# PERMIT

## ON-SITE SEWAGE DISPOSAL SYSTEM HOWARD COUNTY HEALTH DEPARTMENT BUREAU OF ENVIRONMENTAL HEALTH

SUBDIVISION: Homewood Crossing LOT NUMBER: 6

ADDRESS: 11421 Hunt Crossing Court PROPERTY OWNER: Toll MD III, LP

A515042-G

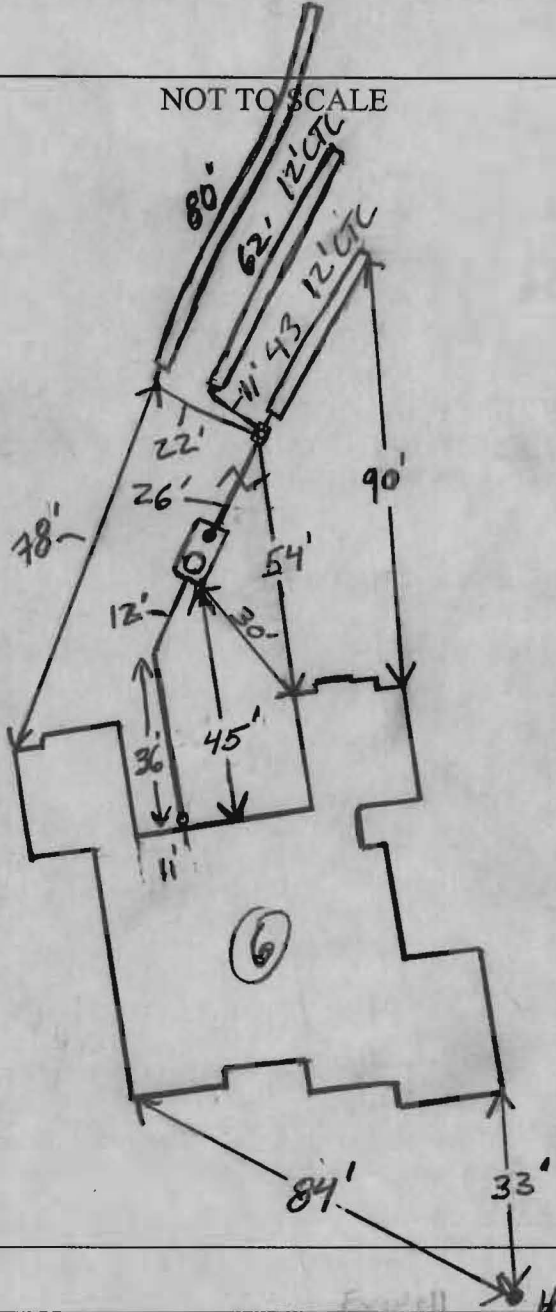
PRE-CONSTRUCTION 9/28/06 Remove some fill @ bottom right corner of septic area. Set tank and D box per plan. Run 40', 60',  
 INSTALLATION 80' trench on contour. (KW) 10/4/06 System complete. Tank and D box set per installation. Trenches run on contour towards road. OK to Backfill (KW)
